NUREG-0493

A DEFENSE-IN-DEPTH AND DIVERSITY ASSESSMENT OF THE RESAR-414 INTEGRATED PROTECTION SYSTEM

**Office of Nuclear Reactor Regulation
U.S. Nuclear Regulatory Commission**

**Manuscript Completed: January 1979
Date Published: MARCH 1979**

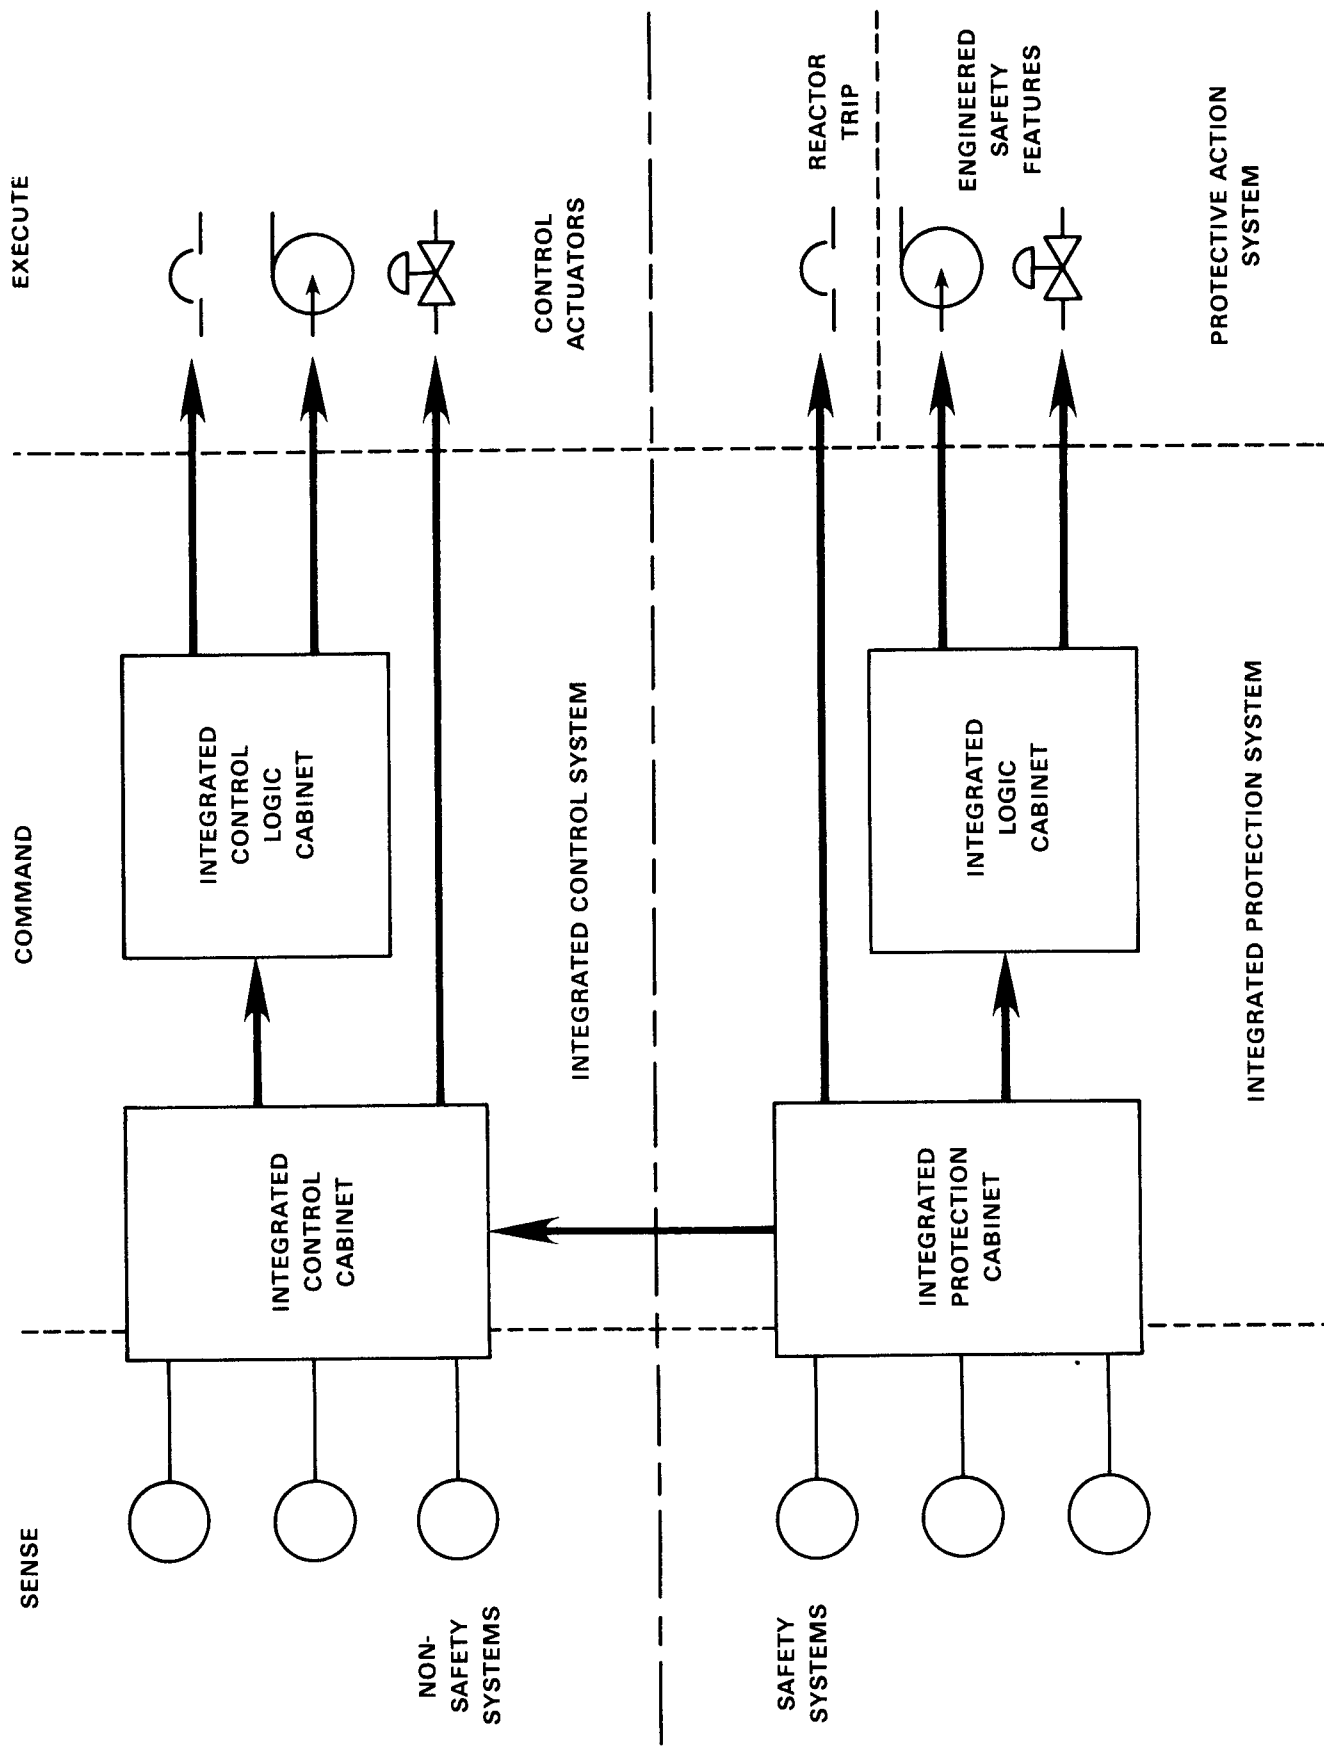
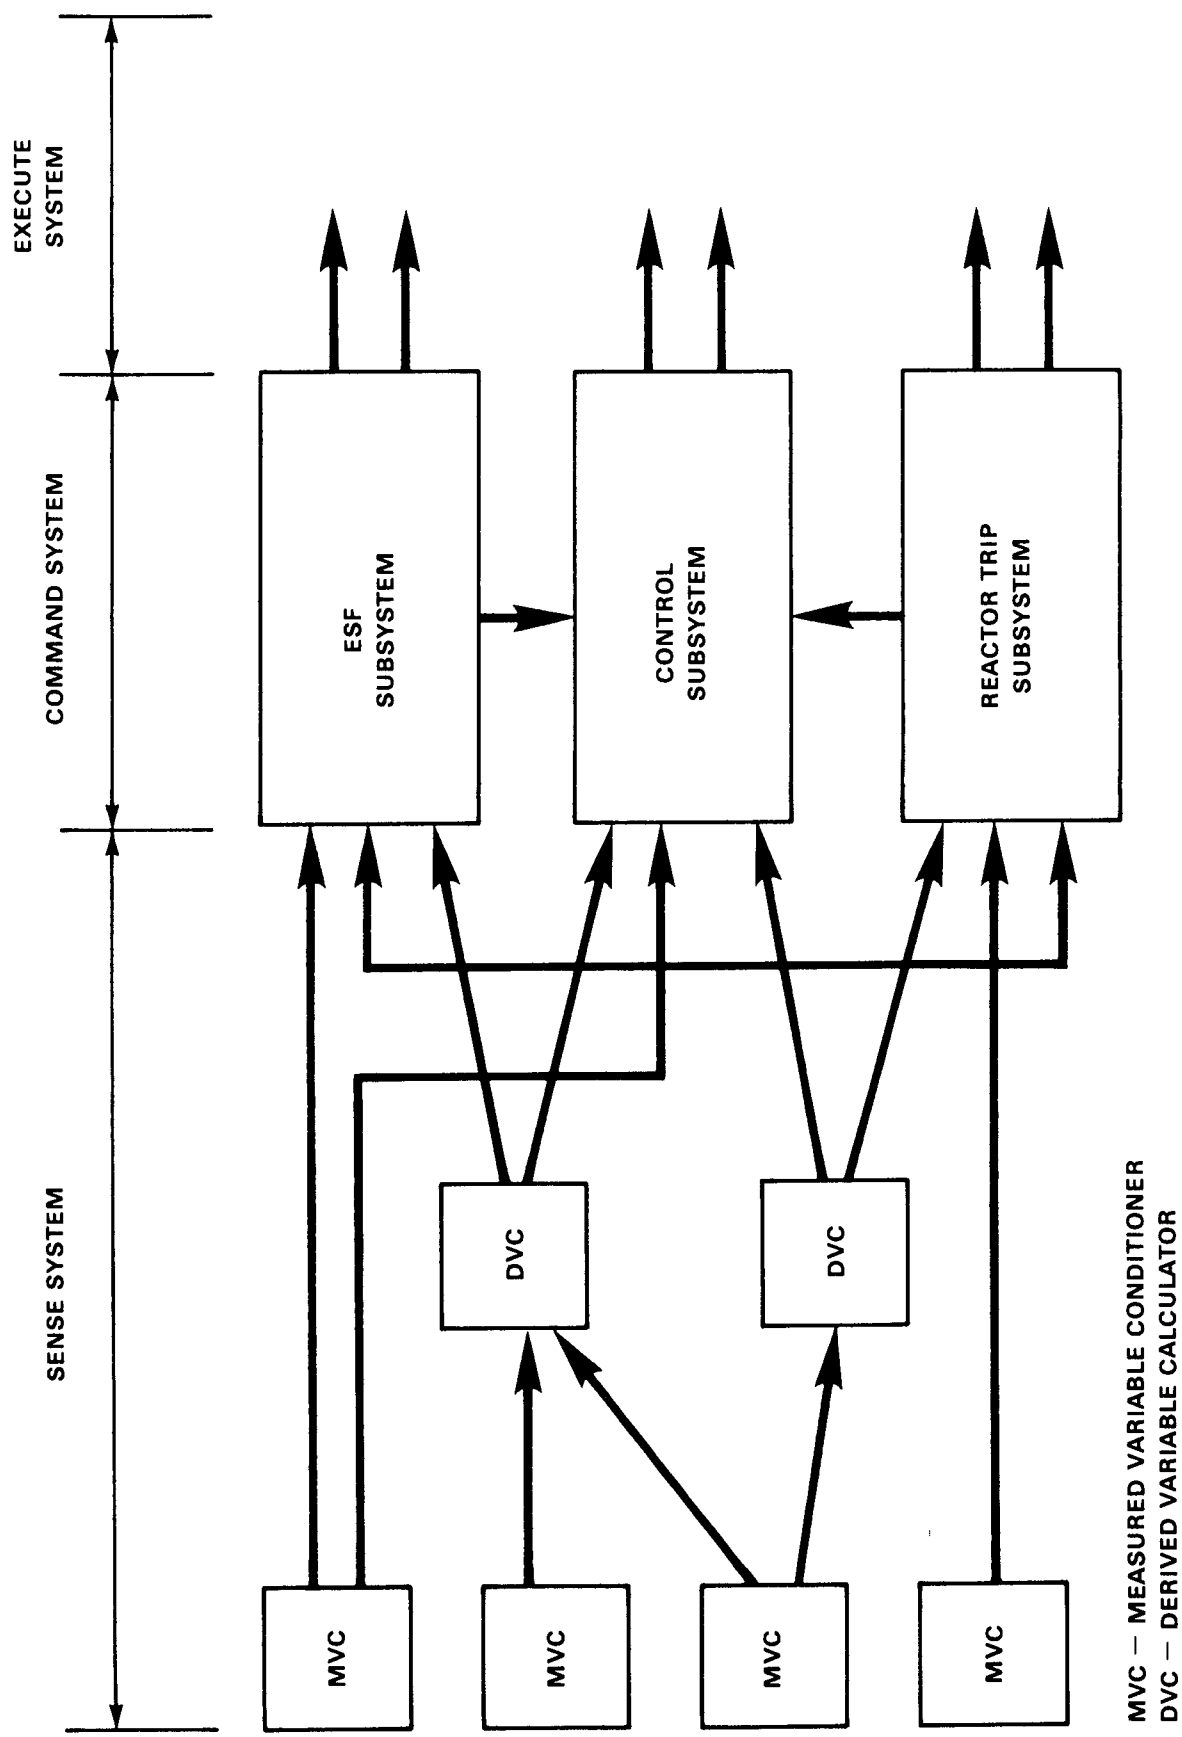
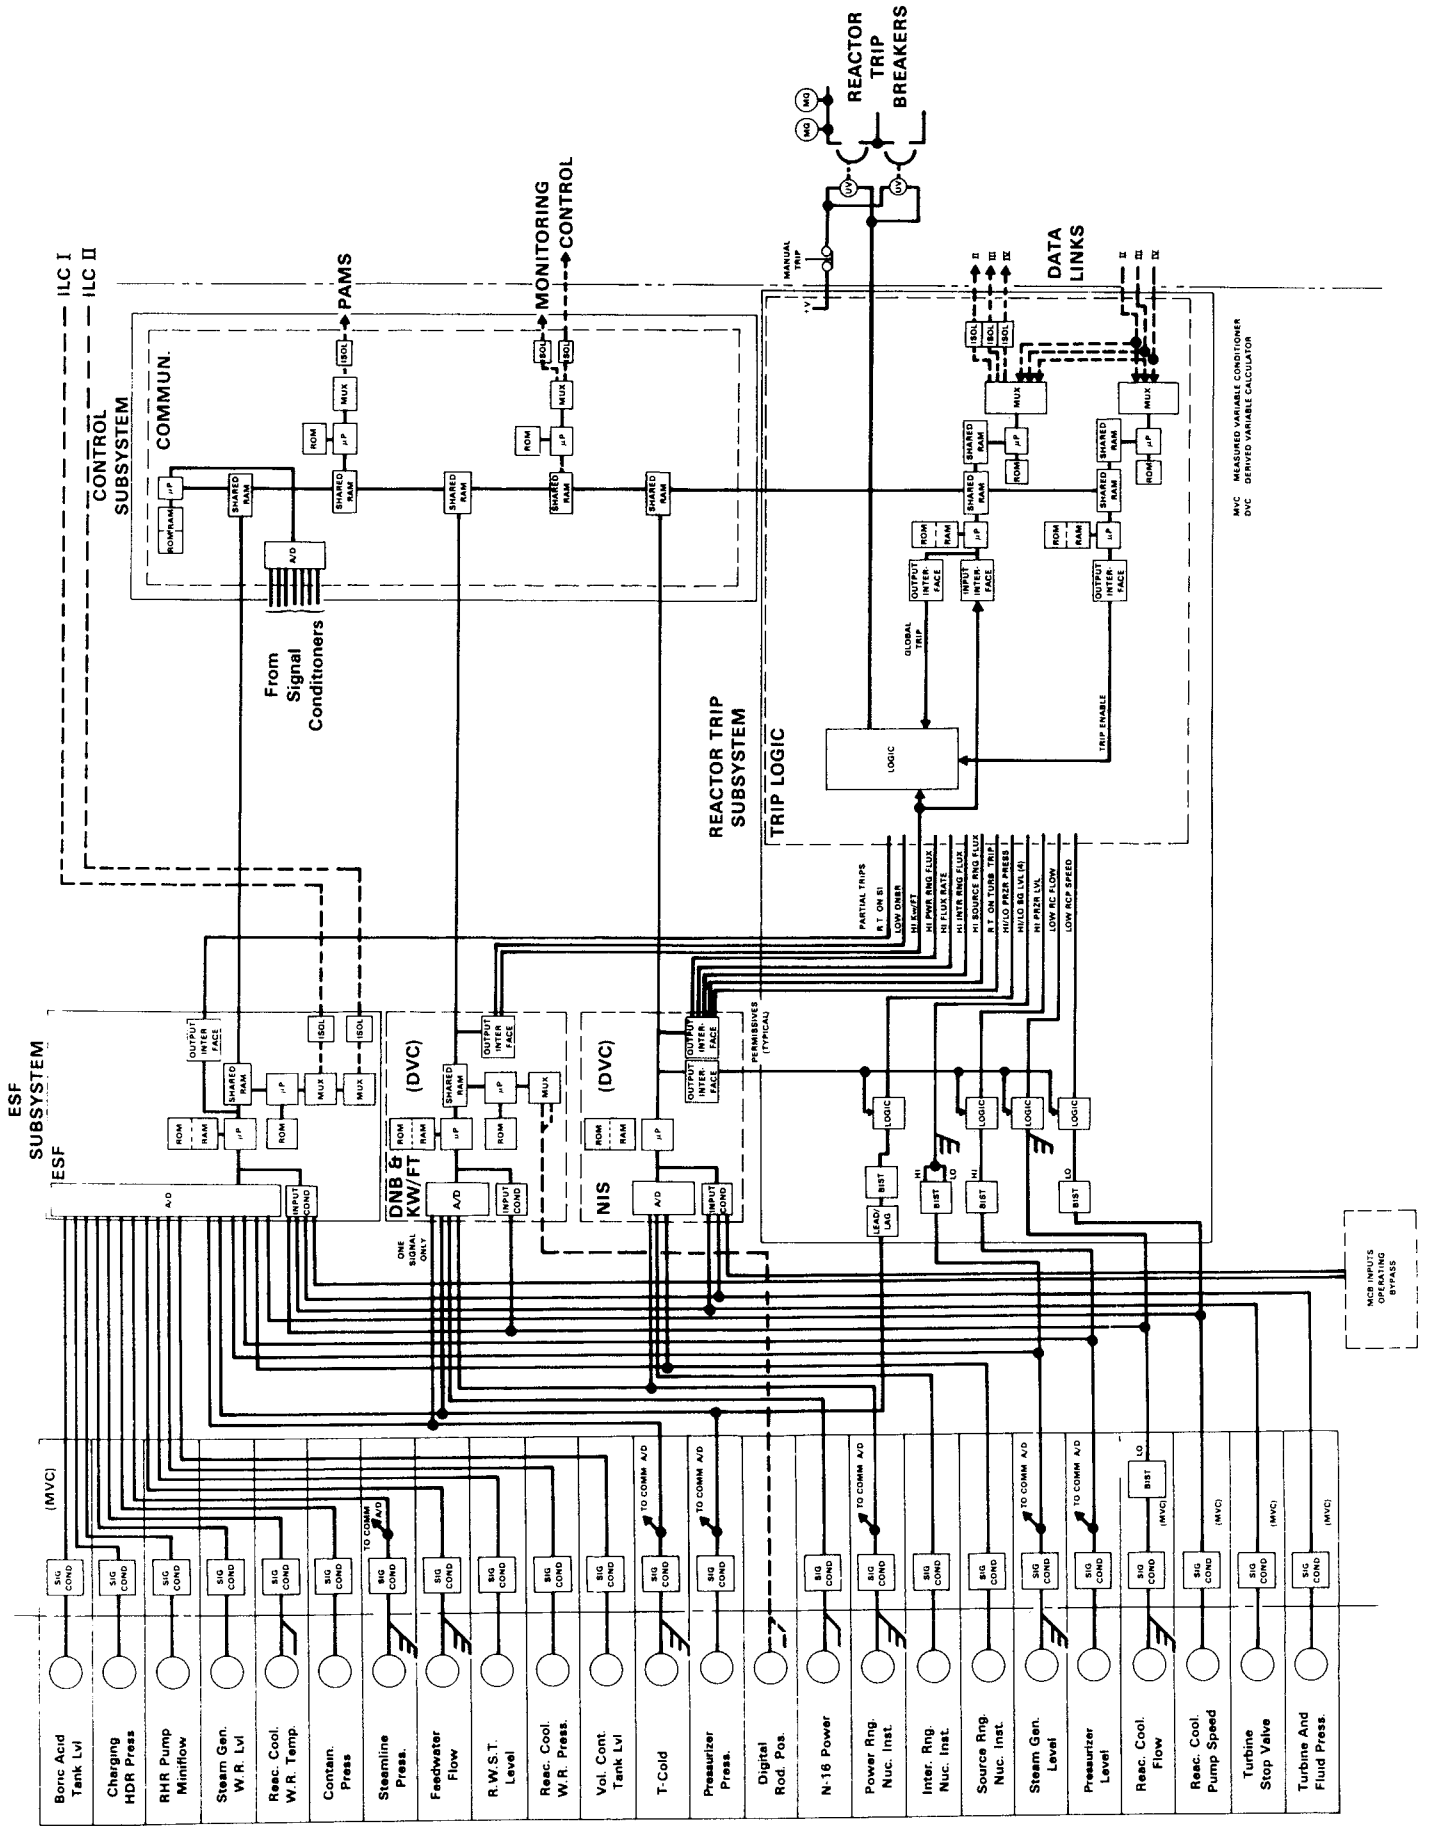
We have reviewed the integrated protection system architecture based on the defense-in-depth guidelines identified in Sections 2 and 3. Based on our review, we conclude that the architecture, as shown in Figure 5, is acceptable for preliminary design approval. The preliminary design approval is predicated on the satisfactory completion of analyses, tests, and resolution of concerns stated herein. We have reasonable assurance that Westinghouse can satisfactorily complete this additional work. The basis of our preliminary design approval and the conditions of our approval are discussed in the following paragraphs.

The staff made an evaluation of the architecture of the integrated protection system presented in Figure 5. The evaluation was based on Guidelines 1 and 2 of Section 3. We note that the architecture presented in Figure 5 provides for three echelons of defense consisting of control, scram, and ESF. Also from Figure 5 and the definitions provided in Reference 21, the following blocks in the terminology of Section 3 of this report are:

Position - Westinghouse has not demonstrated that the common loss of shared signals between protection and control has an insignificant impact upon safety as required by General Design Criterion 24. We require that Westinghouse demonstrate by analysis and/or by test that the loss of any shared signal between the protection system and control system will not have a significant impact on safety. The demonstration must consider the possibility of systematic, nonrandom, concurrent failures of the shared signals or provide a basis for the exclusion of this consideration. Furthermore, we require that this be demonstrated by test and analyses for each type of signal shared between the protection and control system (see Section 4.3.2). The tests and analyses shall also demonstrate that the signal selector performs no protection function.

Position - We require that Westinghouse define and evaluate the credible failure modes of the signal selector and their effects, including the possibility of systematic, nonrandom current failures of the two devices. Our concern is that plant conditions more severe than the design basis of the safety system may result from failure of the signal selector. Modifications of the design will be required for those failure consequences resulting in plant conditions more severe than those for which the plant safety systems are designed.

1. We require that Westinghouse demonstrate by analysis and test that the loss of any signal shared by control and scram or ESF does not significantly affect safety.
2. We require that Westinghouse demonstrate the adequacy of the signal selector for limiting situations (such as one signal failed and one bypassed), for transient operation of the plant, and for spatial asymmetries in process variables. Furthermore, we require that Westinghouse establish administrative and surveillance procedures for operation of the signal selectors under limiting situations.

3. We require that Westinghouse define and evaluate the credible failure modes of the signal selector and their effects, including the possibility of systematic, nonrandom concurrent failure of the two devices. Our concern is that plant conditions more severe than the design basis of the safety system may result from failure of the signal selector. Modifications of the design will be required for those failure consequences resulting in plant conditions more severe than those for which the plant safety systems are designed.
4. We require that Westinghouse demonstrate by test and/or analysis that the operation of the signal selector will not result in a challenge to the safety system during operation of the plant.
